# Reliability Analysis Update

Hamad Ahmed  
Sub Regional RTEP Committee – PJM  
West

# Scope Change Baseline Reliability Projects

# APS Transmission Zone: Baseline b3773: Warfordsburg Capacitor Bank

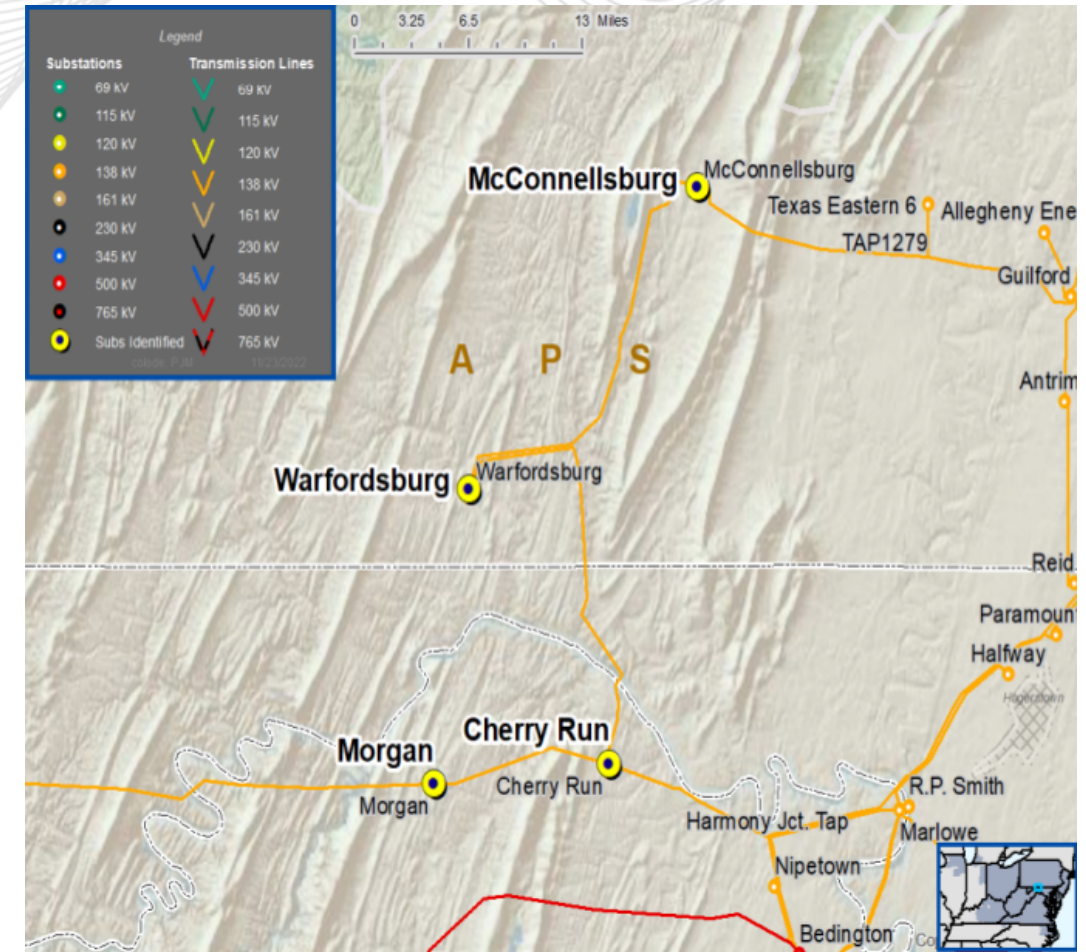
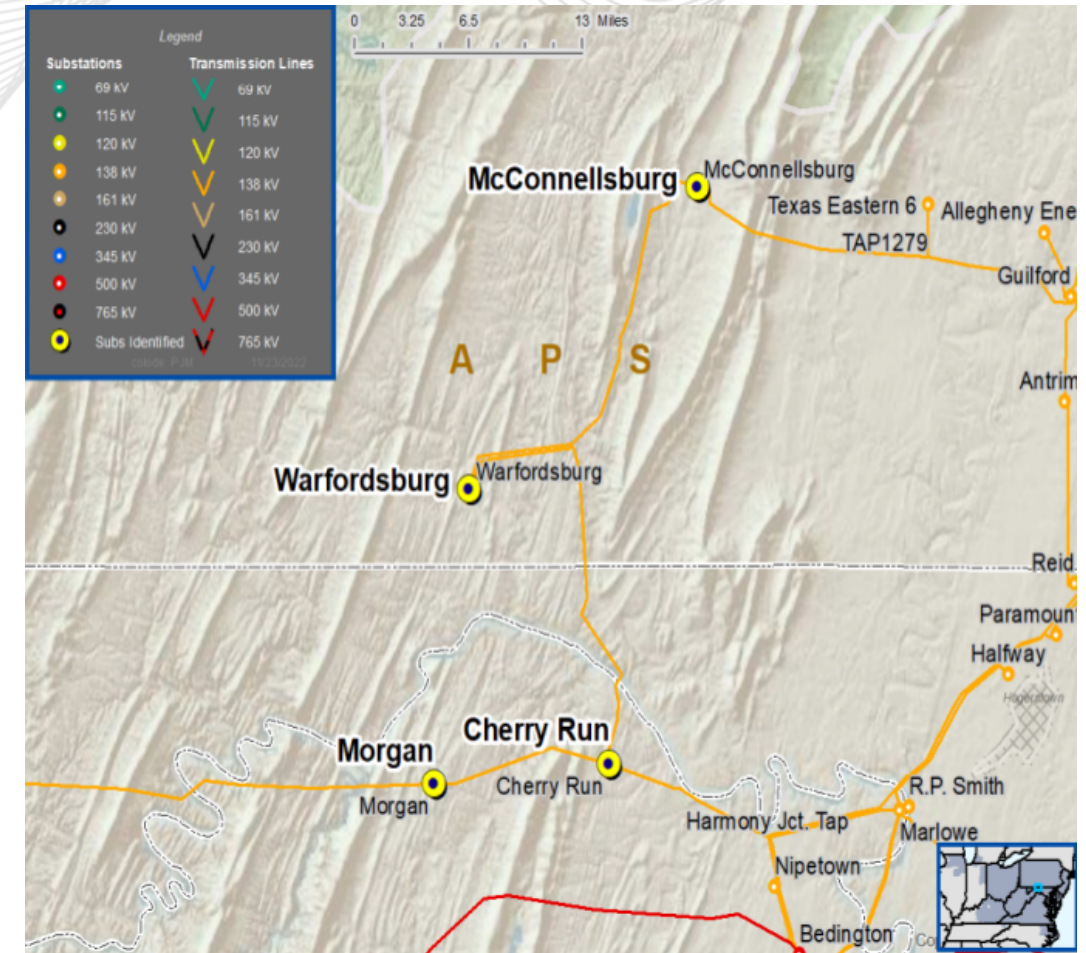
In 2027 RTEP Winter case, Low Voltage is observed at McConnellsburg, Warfordsburg, Morgan and Cherry Run 138 kV substation due to N-1-1 contingencies.

Install (1) 33 MVAR switched capacitor, 138 kV breaker, and associated relaying at McConnellsburg Substation.

FirstEnergy has identified significant challenges with installing a 138 kV capacitor at McConnellsburg Substation, including the need for a fence expansion and new control building and therefore, are proposing to install the 138 kV capacitor at Warfordsburg Substation instead. There is no change in cost or In-service date

Install (1) 31.7 MVAR switched capacitor, 138 kV breaker, and associated relaying at Warfordsburg Substation

**Estimated Cost: \$3.05M (No change)**

**Projected in-service date: 6/1/2027 (No change)**
